15557-TUL-XX-XX-RP-C-91002 Issue 01

Land East of Longwater Road, Finchampstead, Longwater Road, Wokingham, RG40 3TS.

Discharge of Condition Consultation (Application Number 260289)

Planning Response for Conditions 7, 9 & 11.

Outdoor Lighting Report

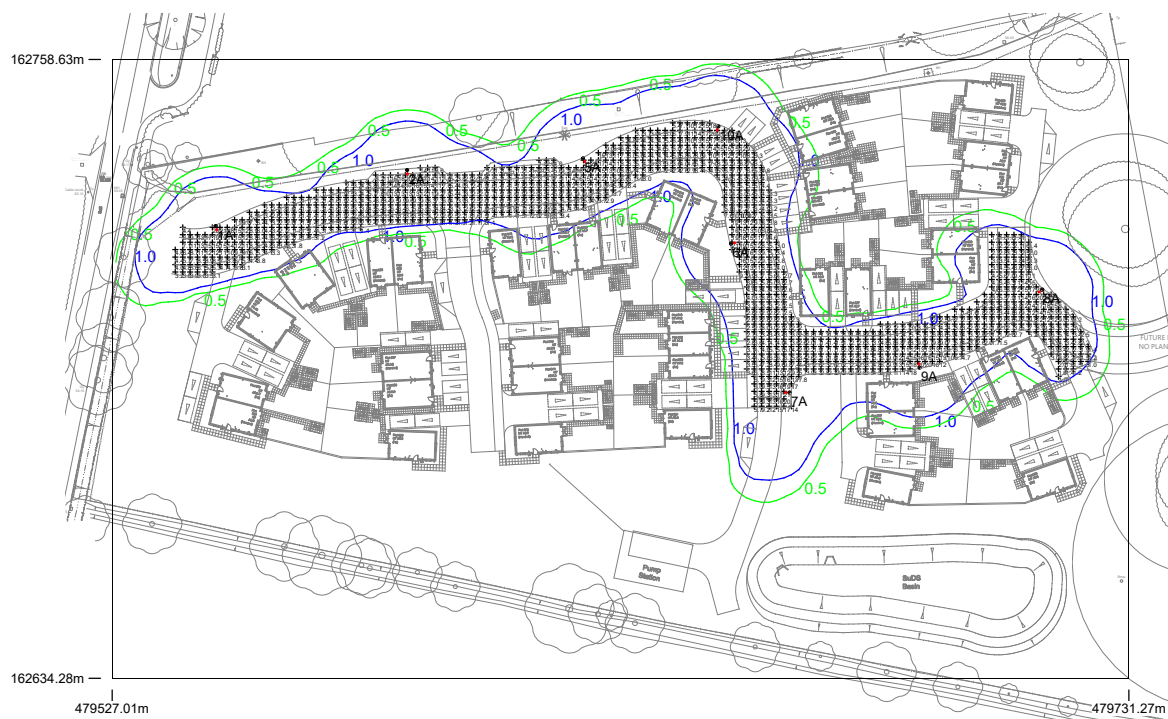
- *HRA50/10 required instead of AC10 (Surface course).*
- *Lighting drawings are required in order to allow comments to be made on the lighting strategy.*

- Lighting design provided.

Refer to DW Windsor Outdoor Lighting Report and drawing 26-086-1B.
